ORIGINATION FORM

Proposed Revisions to a Standard Plans Index

Index Number: 700-040

Index Title: Cantilever Sign Structure

SHEET
1 of 5

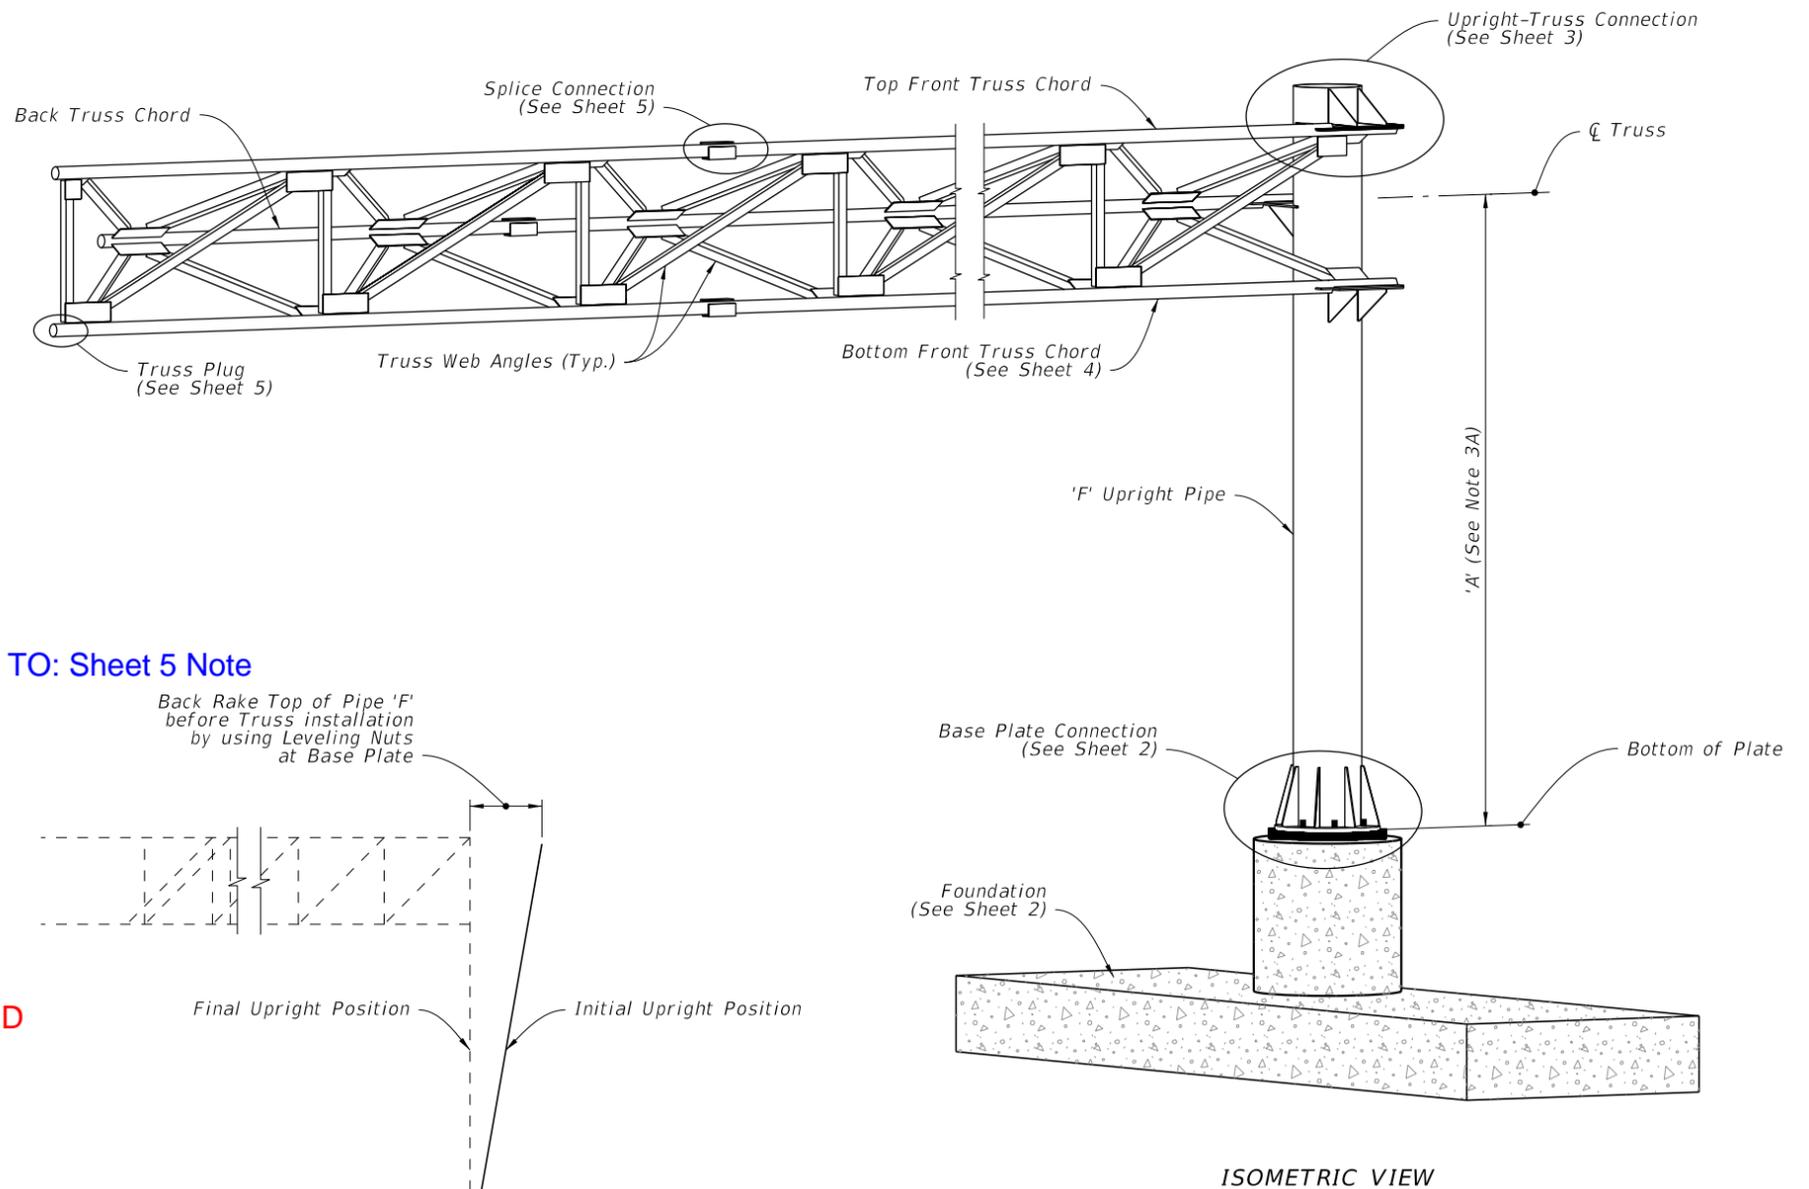
Sheet 1: Updated Notes to General Notes; Added New General Note 1 - "Meet the requirements of Specification 700."; Deleted Notes 4 through 7; Moved Note 5.B to Sheet 5 Notes; Renumbered Notes.

UPDATED: GENERAL NOTES:

ADDED NEW NOTE 1: Meet the requirements of Specification 700.

~~4. Materials:~~

DELETED

~~5. Fabrication:~~

MOVED TO: Sheet 5 Note

~~6. Coatings:~~

DELETED

~~7. Construction:~~

GENERAL COMMENT: Some material, construction, and fabrication information was deleted. Information is either already covered in Standard Specifications OR will be added to Section 700, 962 or 965 in conjunction with these revisions.

LAST REVISION	11/01/21	DESCRIPTION:	11/01/22		FY 2022-23 STANDARD PLANS	CANTILEVER SIGN STRUCTURE	INDEX 700-040	SHEET 2 of 5
---------------	----------	--------------	----------	--	------------------------------	---------------------------	------------------	-----------------

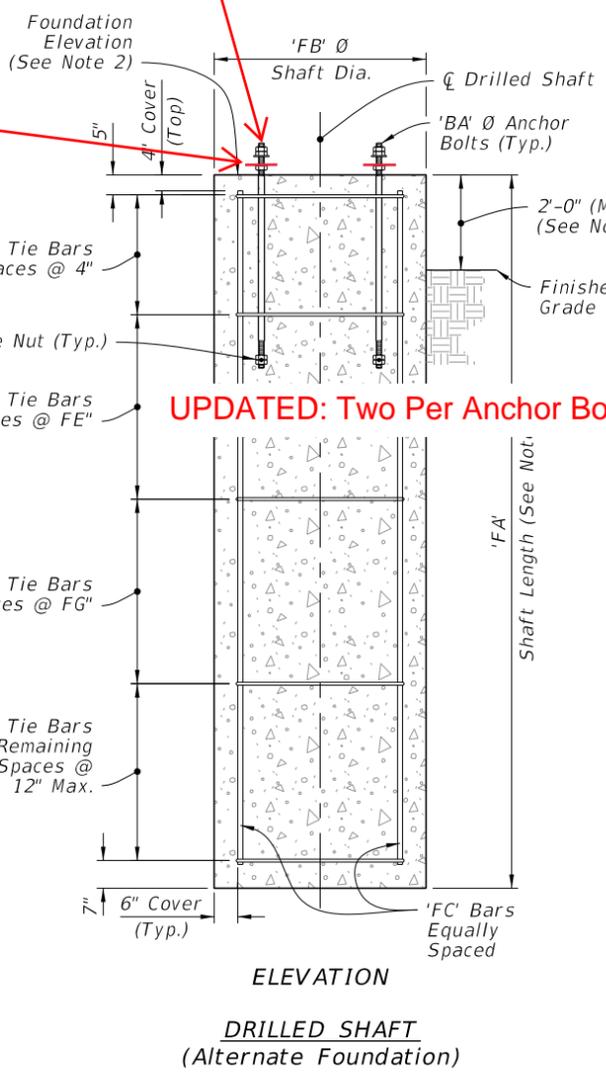
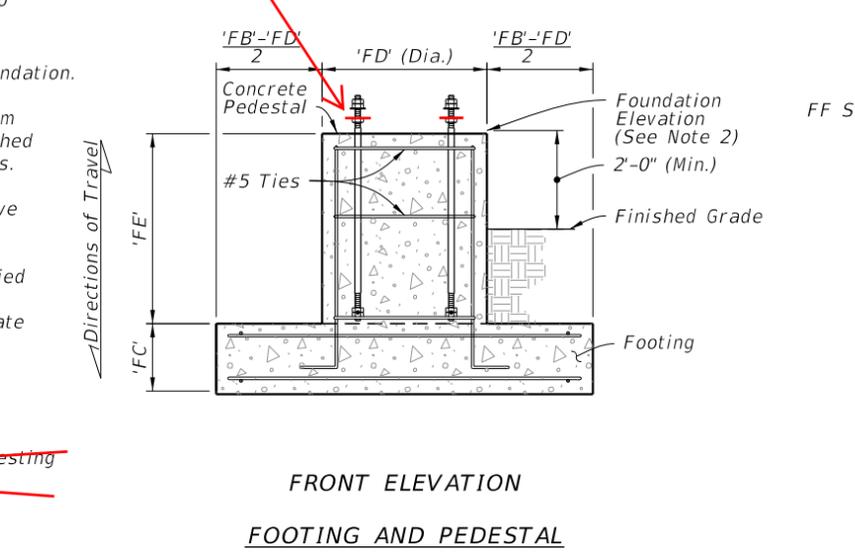
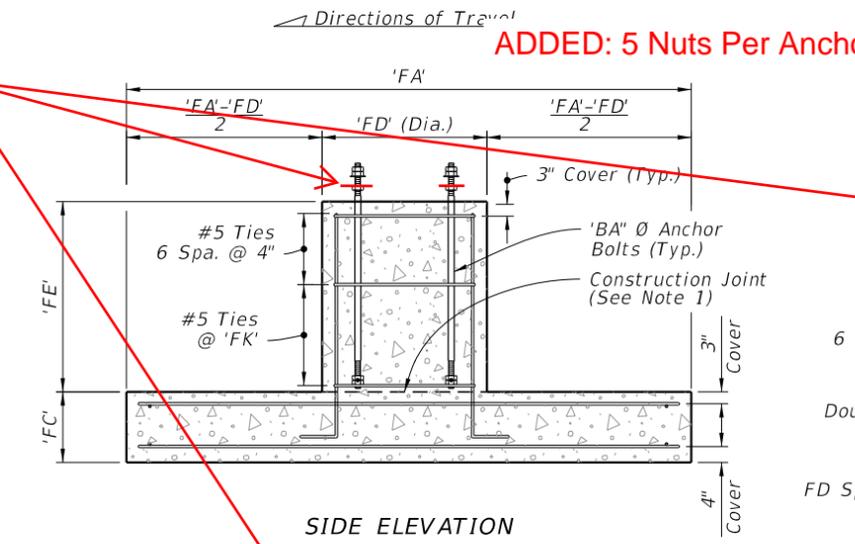
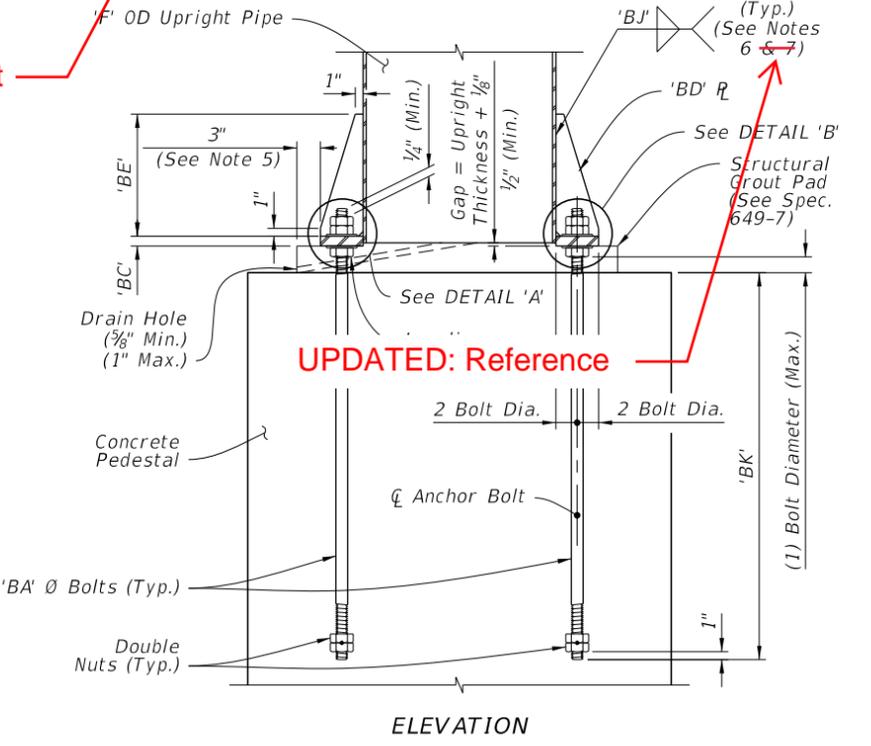
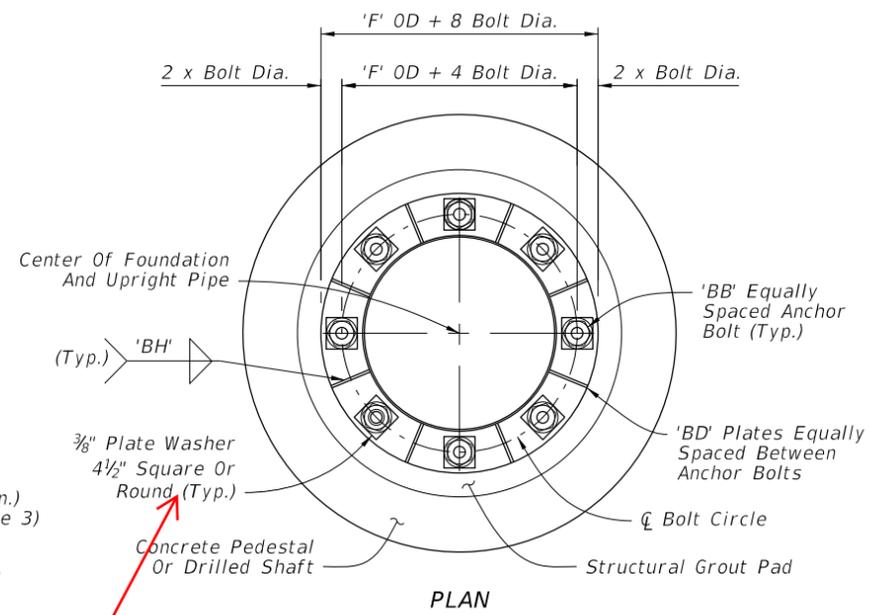
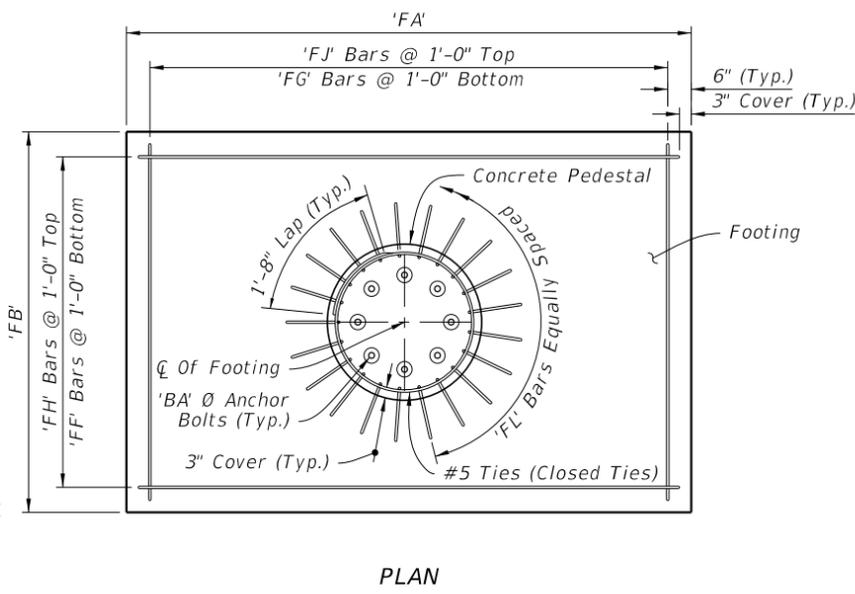
Sheet 2: Deleted Note 7 ; Added Plate Washers to the Anchor Bolts and new callout "5 Nuts Per Anchor Bolt (Typ.)"; in the FOUNDATION details; Updated the Plate Washer callout and the weld references in the BASE PLATE CONNECTION details; Added new note detailing the weld pattern of the 'BD' plates indicating that they should be welded in a star pattern.

ADDED NEW NOTE: Weld plates 'BD' in a star pattern. A star pattern is one in which the plates on opposite and near opposite sides of the pole circle are successively welded in a pattern resembling a star. For an 8 plate circle with plates sequentially numbered 1 to 8, weld the plates in the following order: (1, 5, 7, 3, 8, 4, 6, 2).

ADDED: Washers

ADDED: 5 Nuts Per Anchor Bolt (Typ.)

UPDATED: Two Per Anchor Bolt

UPDATED: Reference

DELETED

Sheet 2: New Note - This process is to help prevent residual stress buildup in base plate connection to prevent cracking.

LAST REVISION	DESCRIPTION:
11/01/17	11/01/22

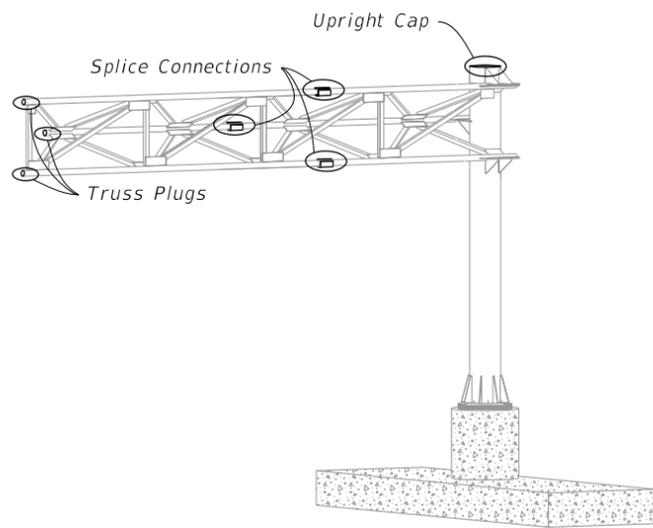
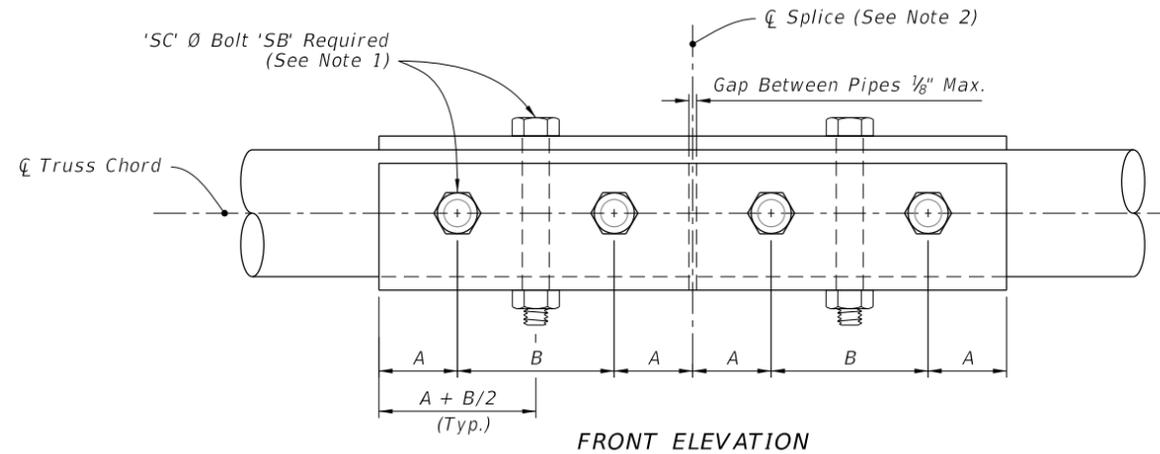
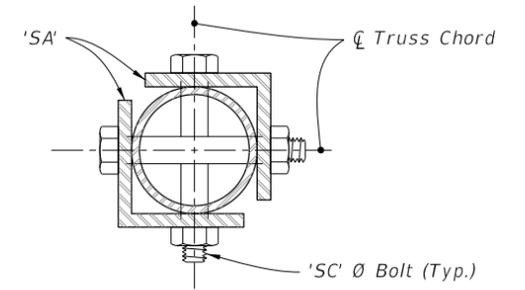
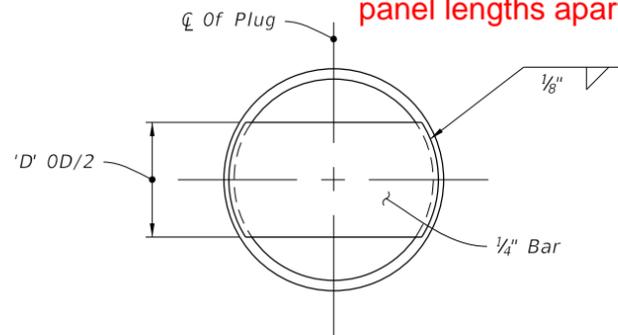
Sheet 5: Added General Note 5.B as New Note 3 - "Chord Splices: "SD" Panel from upright is the closest panel in which chord splice may be used. See Plans for CANTILEVER SIGN STRUCTURE DATA TABLE. Minimum splice spacing is two truss panel lengths apart."

ADDED NOTE 3:
 Chord Splices: "SD" Panel from upright is the closest panel in which chord splice may be used. See Plans for CANTILEVER SIGN STRUCTURE DATA TABLE. Minimum splice spacing is two truss panel lengths apart
